Accessibility Review Report – DA Review

Project Title: Proposed Carpark Reconfiguration – Shopping Centre
155 Bennett Road, St Clair

Job Number: 7325

Report Version: ADR_DA_7325_v1.0

Figure 1 – Concept Carparking Reconfiguration Plan

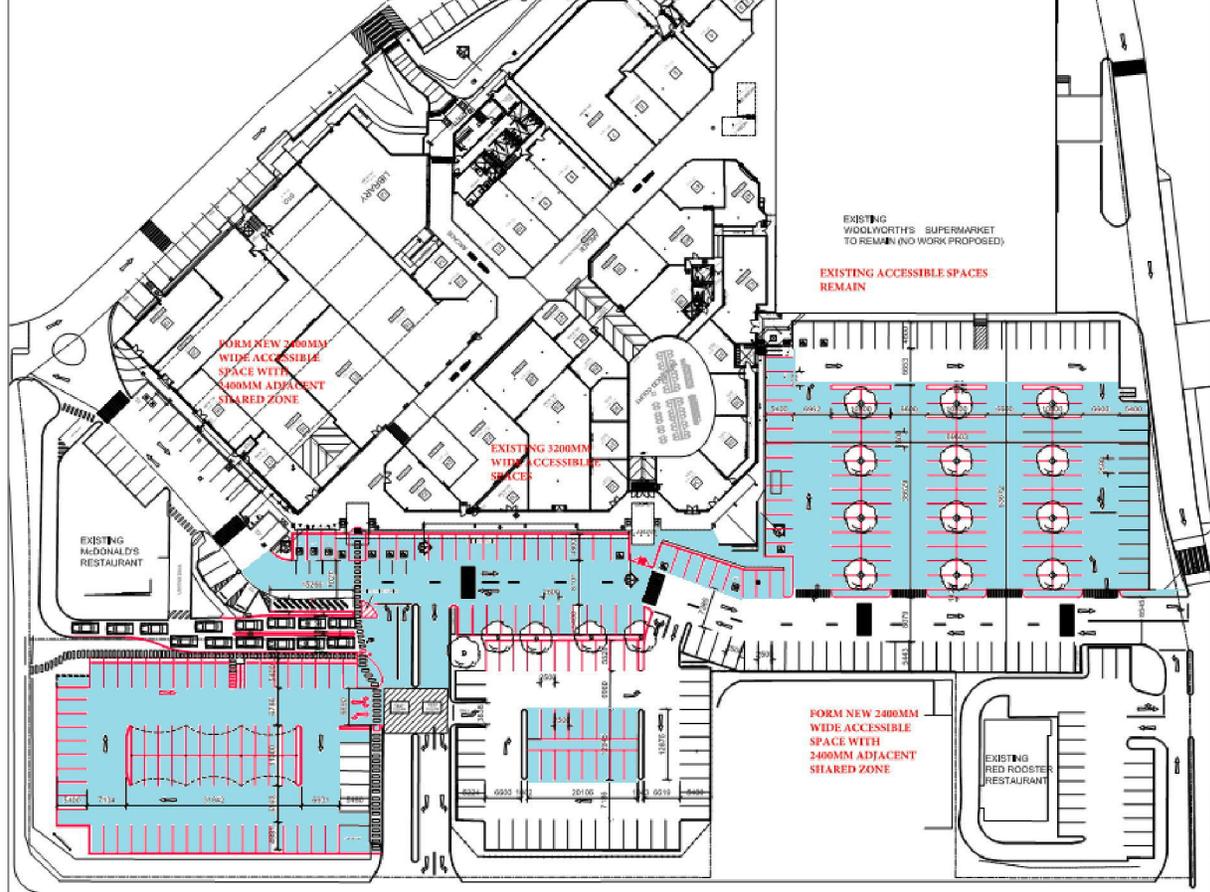
The following plan extract is provided as a visual representation of the proposed ‘new works’. A detailed assessment will be required at the Detailed Design Stage to ensure compliance is achieved.

Highlighted Blue – 'New Works' as shown by Red Outline
